802.3ck D1.3

MTF IL and RL Comments

#122,#22,#178,#123 ,#21 and #269

Chris DiMinico
MC Communications/PHY-SI LLC/Panduit
cdiminico@ieee.org

MTF ERL- comment#122,#123,#178

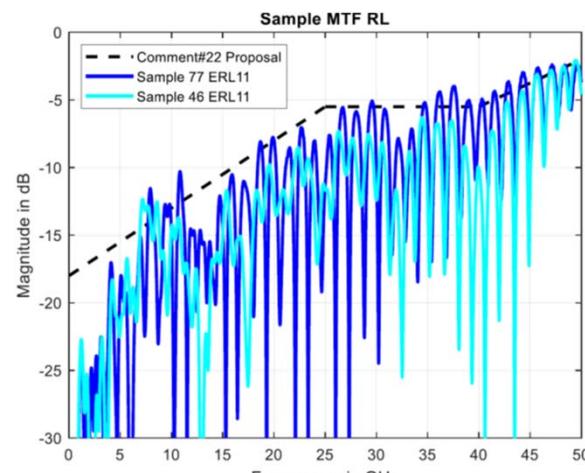
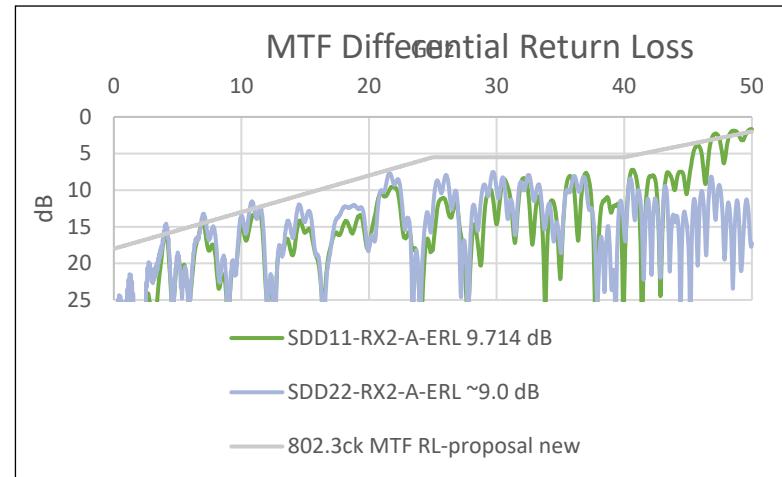
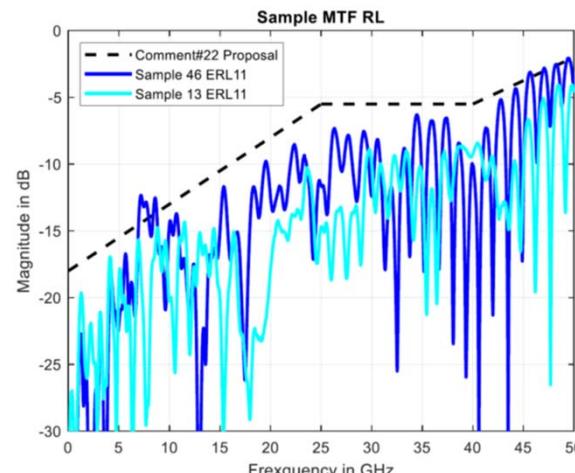
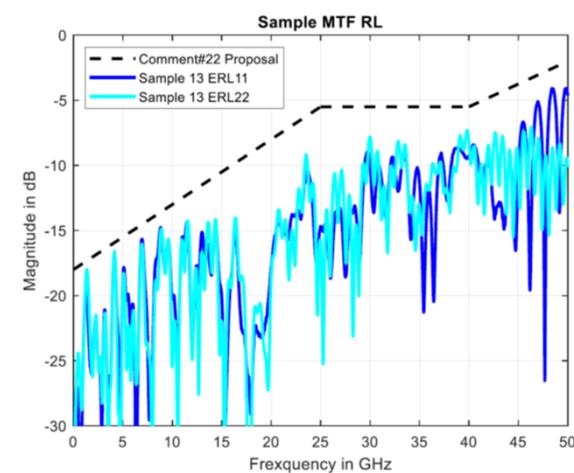
- Specify MTF ERL with 9 dB requirement
- Use MTF ERL Parameters Table Below

Shown difference between ERL ~7dB and ERL ~8dB

Shown difference between ERL ~8dB and ERL ~10dB

The difference caused by the limit line violation >45GHz is ~0.2dB ERL

MTF IL proposal- comment#21

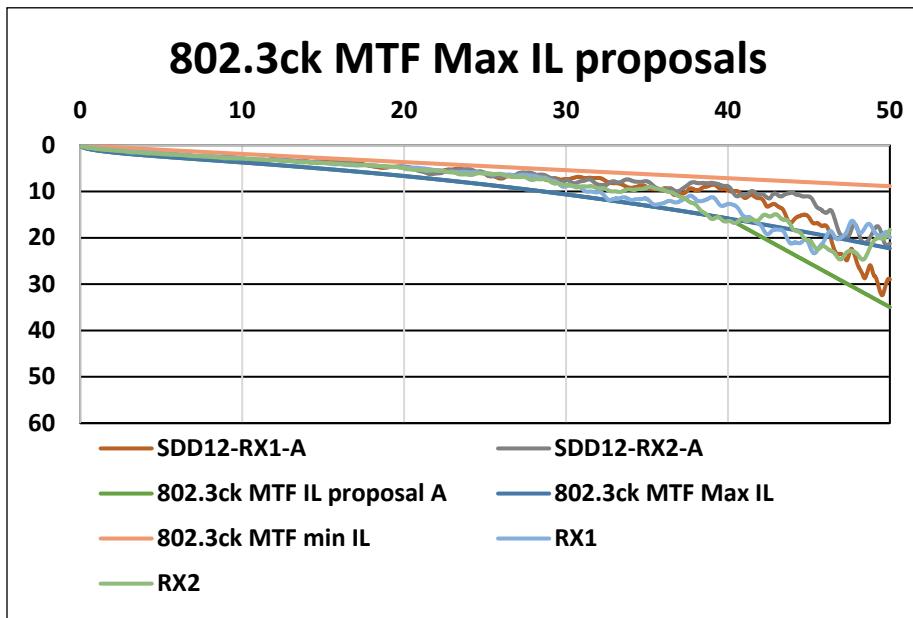
MTF IL proposal A = $1.185 * \text{SQRT}(f) - 0.072 * f + 0.007 * f^2$ $0.01 \text{ GHz} \leq f < 40 \text{ GHz}$
MTF IL proposal A = $1.915 * f - 60.78$ $40 \text{ GHz} \leq f \leq 50 \text{ GHz}$

RX1-TDR PKG OFF
VEC = 7.975 dB
EH = 33.915 mV
ERL = 11.172 dB (11.318 dB, 11.172 dB)
RX2-TDR PKG OFF
VEC = 7.840 dB
EH = 32.138 mV
ERL = 10.710 dB (10.912 dB, 10.710 dB)

RX1-A TDR OFF
VEC = 8.496 dB
EH = 32.737 mV
ERL = 8.336 dB (9.218 dB, 8.336 dB)
RX2-A TDR OFF
VEC = 8.378 dB
EH = 31.549 mV
ERL = 9.069 dB (9.714 dB, 9.069 dB)

MTF RL comment#22

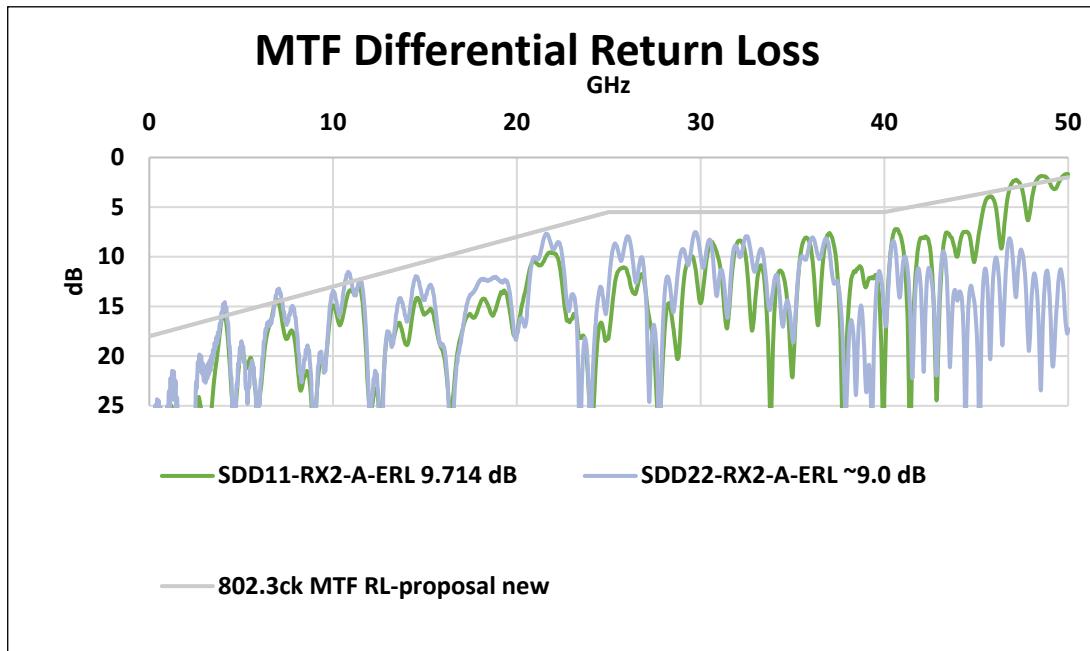
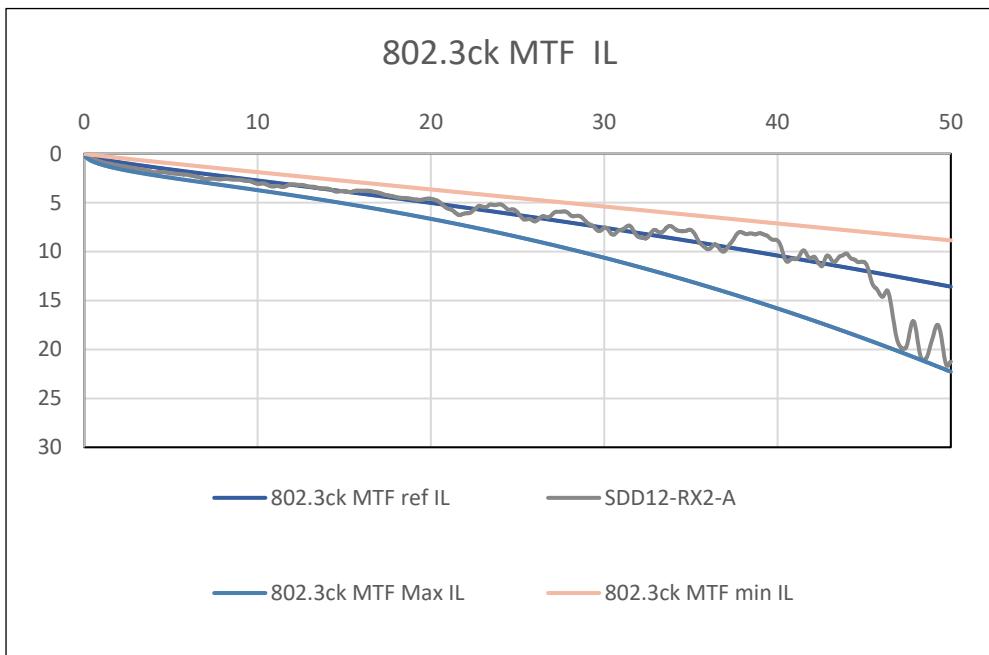
- **MTF RL limit informative**
- **Change RL limit > 40 GHz**

PROPOSAL: Differential Return Loss =

$$18 - 0.5 * f_{\text{GHz}} \quad 0.05 \text{ GHz} \leq f_{\text{GHz}} < 25 \text{ GHz}$$

$$5.5 \quad 25 \text{ GHz} \leq f_{\text{GHz}} < 40 \text{ GHz}$$

$$-.35 * (f_{\text{GHz}} - 40) + 5.5 \quad 40 \text{ GHz} \leq f_{\text{GHz}} \leq 50 \text{ GHz}$$

Figure 162B-3—Mated test fixtures insertion loss

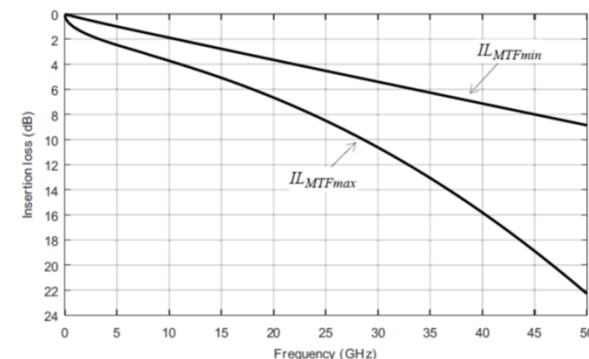
Figure 162B-3, Mated test fixtures insertion loss, shows the maximum and minimum IL but not the reference IL.

Please show the reference insertion loss of the mated test fixture also, on the same graph.

PROPOSED REJECT.

The reference IL does not include ILD and therefore not representative of MTF IL i.e., as a reference over frequency.

**Proposed response: AIP
Change upper frequency EQ: 162B-5
to 30 GHz. Plot MTF reference IL
Figure 162B-3.**
